C I T Y O F B O U L D E R
PLANNING BOARD AGENDA ITEM
MEETING DATE: Aug. 18, 2016

AGENDA TITLE: CONCEPT PLAN & REVIEW - Redevelopment of the existing seven-acre apartment site located at 1550 Eisenhower Drive with a new three-story apartment complex Eastpointe Apartment Homes, consisting of 236 proposed units in five buildings with below grade parking and on-site recreational amenities under case review no. LUR2016-00043.

DATE OF COMMENTS:	**July 1, 2016**
CASE MANAGER:	**Elaine McLaughlin**
PROJECT NAME:	**Eastpointe Apartment Homes**
LOCATION:	**1550 EISENHOWER DR**
COORDINATES:	**N02W01**
REVIEW TYPE:	**Concept Plan Review & Comment**
REVIEW NUMBER:	**LUR2016-00043**
APPLICANT:	**Jeffrey Smith**
DESCRIPTION:	**CONCEPT PLAN REVIEW AND COMMENT: Redevelopment of seven acre site with 236 units in five three-story buildings with below grade parking.**

Building Design (Elaine McLaughlin, 303-441-4130)

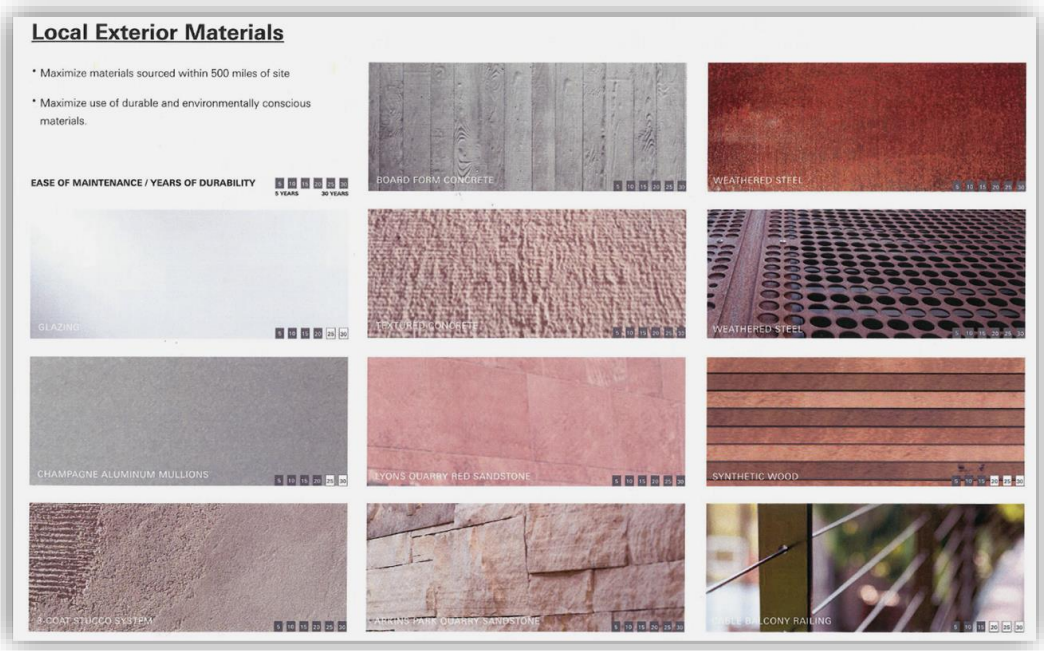
1. While early in the planning process, the applicant provided a strong palette of materials. As project plans progress, the applicant should reference the Site Review criterion (9-2-14(H)(2)(F)(xii) that requires, "*Exteriors of buildings present a sense of permanence through the use of authentic materials such as stone, brick, wood, metal or similar products and building material detailing.*" While most of the palette appears to address this criterion, the applicant should consider less use of "stucco" as a primary finish material.
